Staff Report
City of Richmond, Virginia

LandUse1Commission of Architectural Review

5. COA-125156-2023	Final Review	Meeting Date: 2/28/2023
Applicant/Petitioner	Linnea Gerwig	
Project Description	Alterations to the rear façade including the enclosure of a two-story rear porch and new openings; construct a rear accessory building.	
Project Location		
Address: 612 N. 27 th St.		
Historic District: Church Hill North		
<p>High-Level Details:</p> <p>The applicant proposes to alter the rear of a 1820s Federal Style, three-bay, frame house. The rear two-story covered porches will be enclosed, existing rear windows will be enlarged, and new rear door overhand with vertical side slats will be installed.</p> <p>Work will include the installation of a new rear shed with a shed roof.</p>		
Staff Recommendation	Approval	
Staff Contact	Alex Dandridge, alex.dandridge@rva.gov , (804) 646-6569	
Previous Reviews	An application for a Certificate of Appropriateness was reviewed and approved the Commission for this property in December 2021. That request included the construction of a large new rear addition onto the property. The Commission was very supportive the addition's contemporary design and t

Figure 4. Footprint of original dwelling depicted on F.W. Beers Atlas (c.1877)

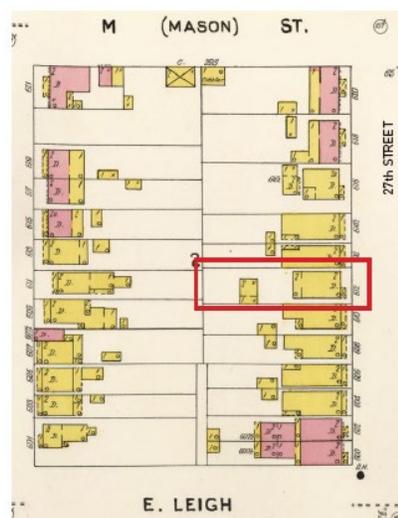
<p>New Construction – Doors and Windows, #2, pg. 49</p>	<p><i>The architectural appearance of original windows should be used as models for new windows. Changes in the sash, depth or reveal, muntin configuration, frame or glazing is strongly discouraged. New glass should be clear without reflective coatings, to be compatible with original class.</i></p>	<p>The enclosure of the rear side two-story porches will be done using fiber cement panels and vertical trim pieces. New casement windows will be installed within the panels and between the vertical trim pieces. The use of large casement windows maintains the visual open appearance of this portion of the building and the references the openness of the existing porches.</p>
<p>Residential Outbuildings, pg. 51 #1-3</p>	<ol style="list-style-type: none"> 1. <i>Outbuildings, including garages, sheds, gazebos and other auxiliary structures, should be compatible with the design of the primary building on the site, including roof slope and materials selection.</i> 2. <i>Newly constructed outbuildings such as detached garages or tool sheds should respect the siting, massing, roof profiles, materials and colors of existing outbuildings in the neighborhood.</i> 3. <i>New outbuildings should be smaller than the main residence and be located to the rear and/or side of the property to emphasize that they are secondary structures.</i> 	<p>The new shed will be 259 square feet and will be less than 12' in height.</p> <p>The proposed rear shed is comparable in massing and form to other outbuildings in the area and is subordinate in size to the principal dwelling. The proposed design uses materials such as a standing seam metal roof and horizontal siding, which are compatible with materials found throughout the district.</p> <p>Additionally, staff notes that Sanborn maps indicate that accessory structures have been present on the property at various points in time (see Figures 4-6).</p>
